Moody's Collision Ctr.

**CITY OF PORTLAND, MAINE  
DEVELOPMENT REVIEW APPLICATION  
PLANNING DEPARTMENT PROCESSING FORM  
Planning Copy**

**Minor Site Plan Application**  
**Moody's Collision Center, Presumpscot Street, Portland Maine**

**Moody's Collision Center – Minor Site Plan Submission, Review Comments**

Figure 1 – Overall Site Plan View

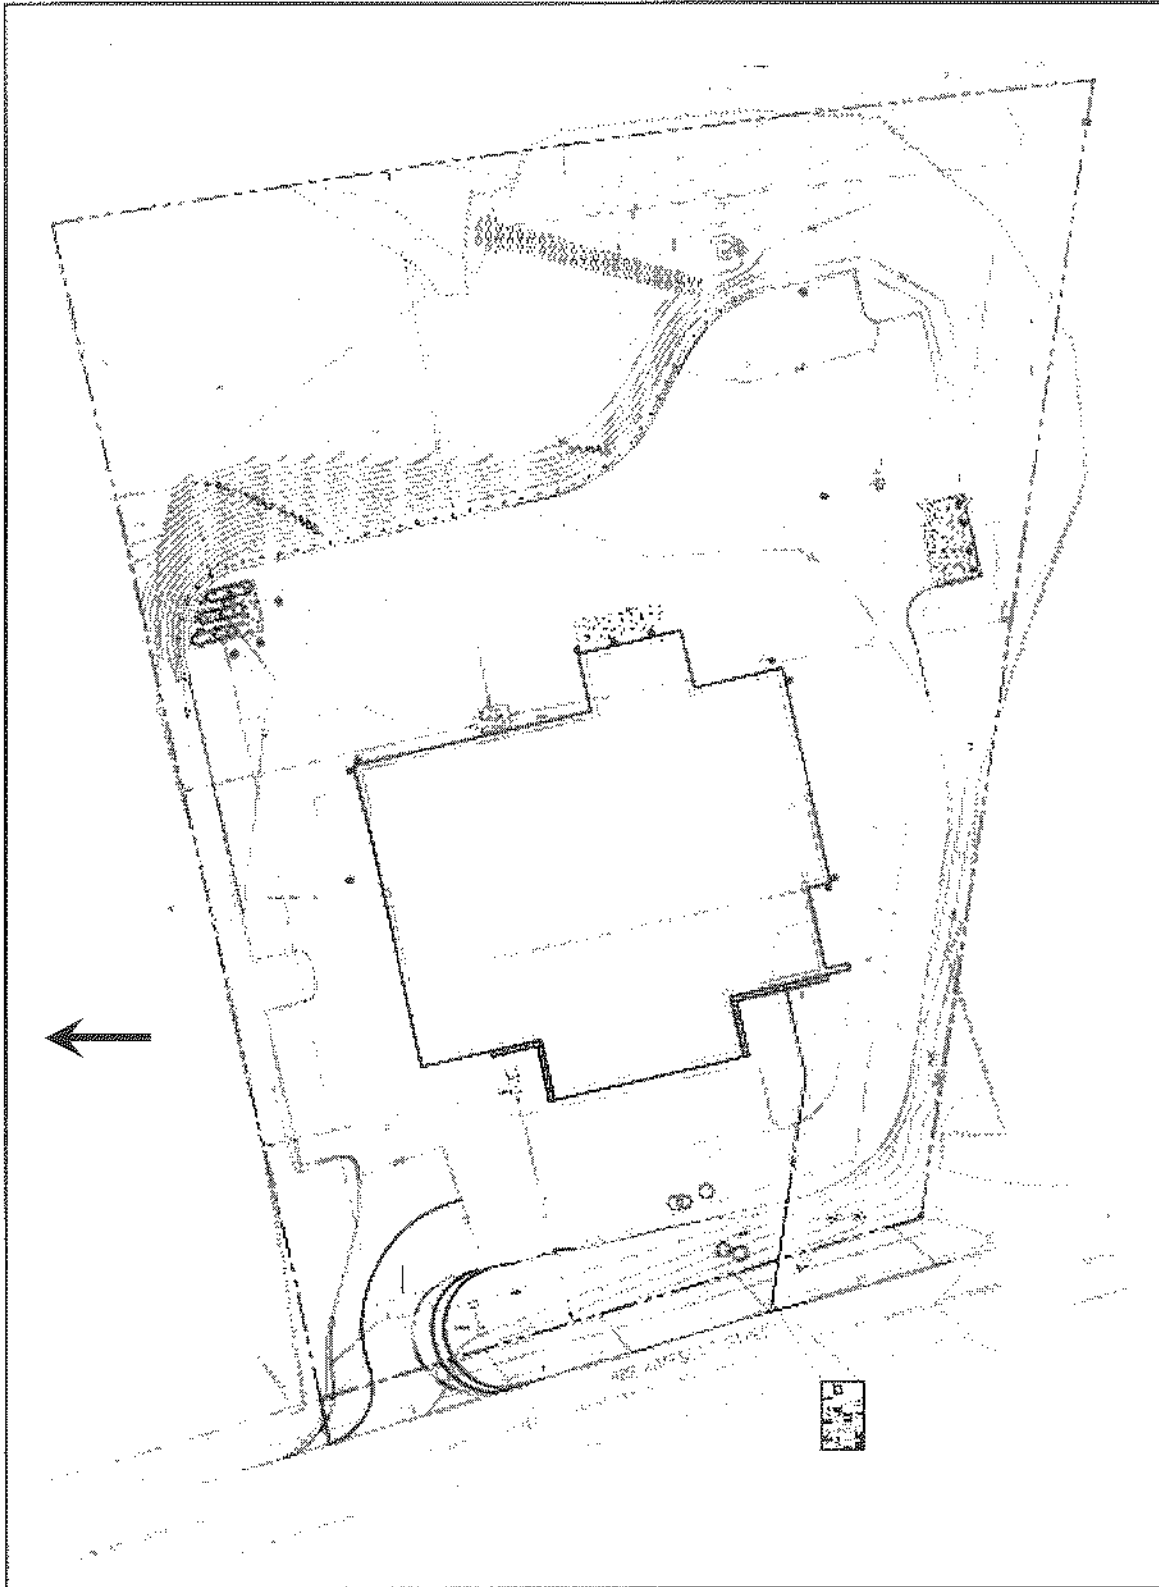
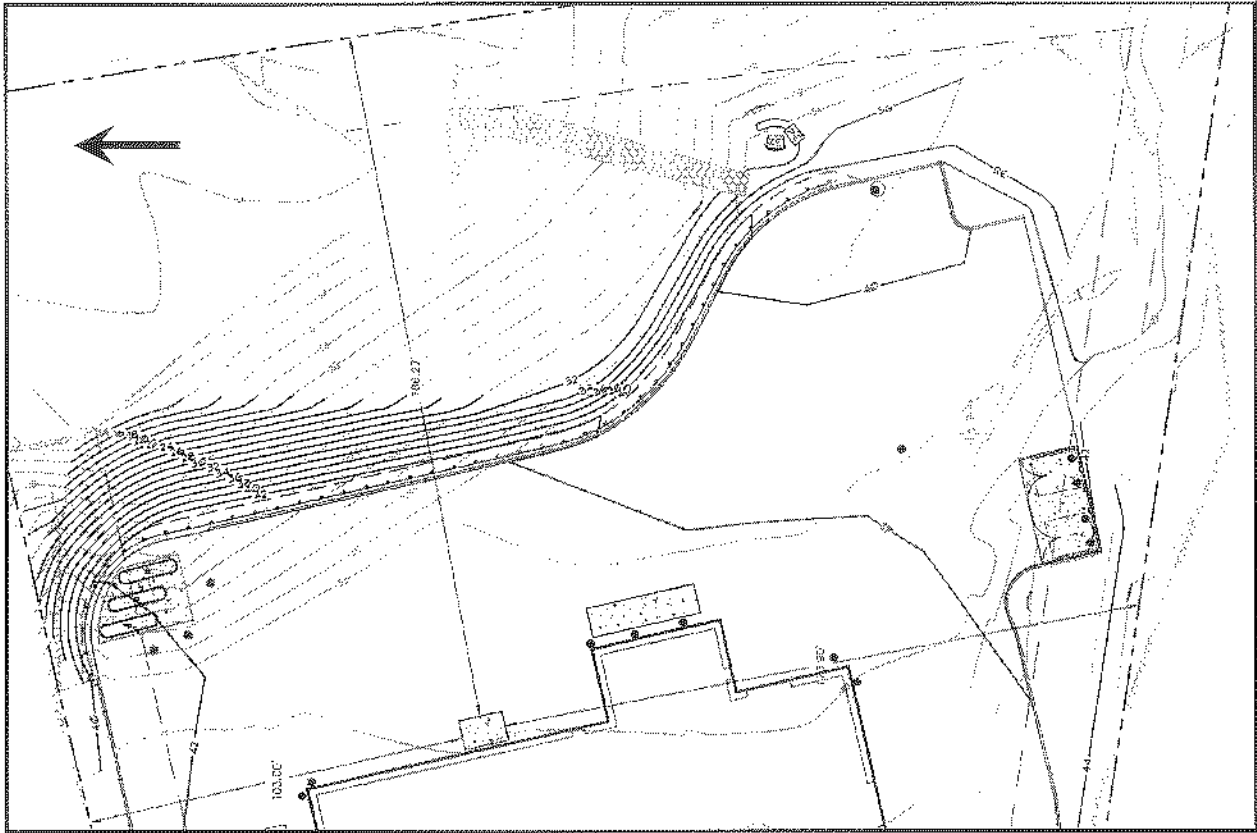
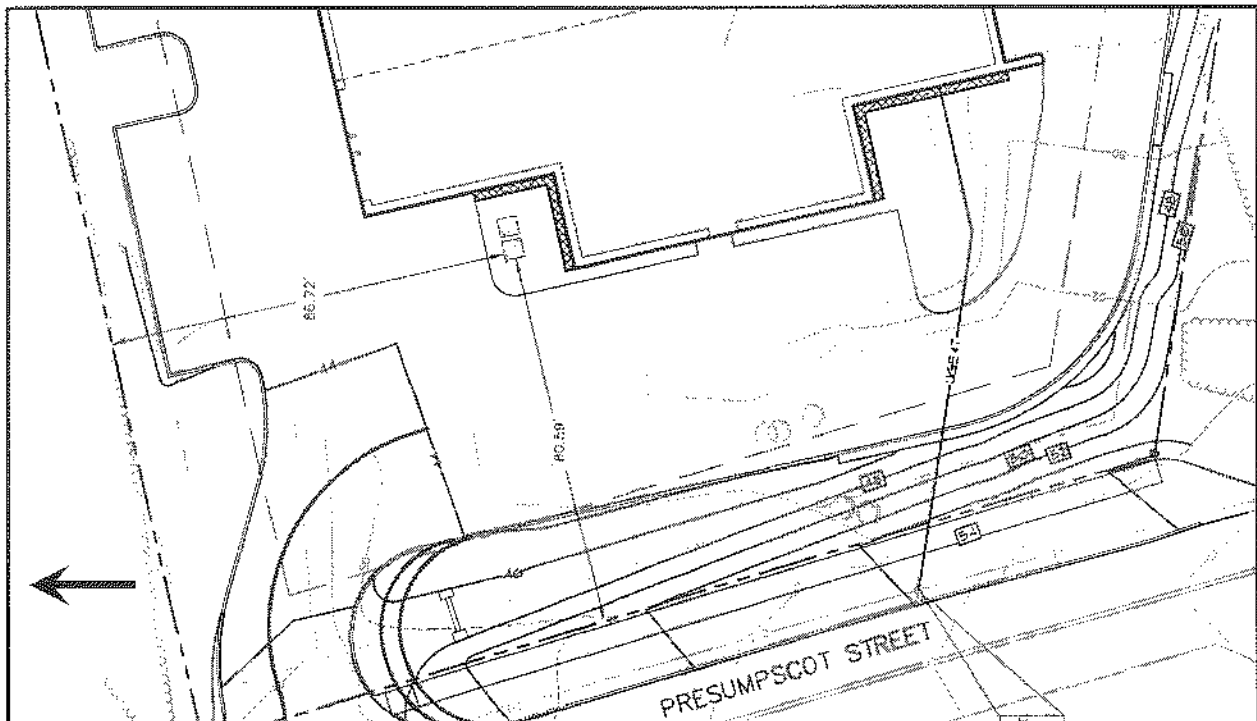
3. *There are two sound reading levels given for the 30 Ton Rooftop unit - one is 95 dBs and the other is 80 dBs, which are both in excess of 14-252 maximum permissible sound levels. 70 dBA is the maximum allowed from 7:00 am to 10:00 pm. 55 dBA is the maximum allowed from 10:00 pm to 7:00 am, as measured at or within the boundaries of any residential zone. Further verification will be needed to show compliance with the sound requirements.*

There are two small air conditioning units located in the front (Presumpscot Street) side of the facility which have a rating of 80 dBs. There is a larger unit located in the rear of the facility which has a rating of 95 dBs. The rear unit is located on the 8' x 12' concrete pad shown on the plans. It should be noted that this pad was previously mislabeled as a generator pad. The plans have been updated to reflect an air conditioning pad.

Comment	Lw dBA	Prop Line	Distance - ft	20*LOG(Dist) - 2.4	Lp dBA
30 Ton - Model 360H	95	North	103.00	-37.9	57.1
31 Ton - Model 360H	95	East	186.27	-43.0	52.0
Model 13ACX-48-230 (each)	80				
Model 13ACX-48-230 (both)	83	North	86.00	-36.3	46.7
Model 13ACX-48-230 (both)	83	West	80.00	-35.7	47.3
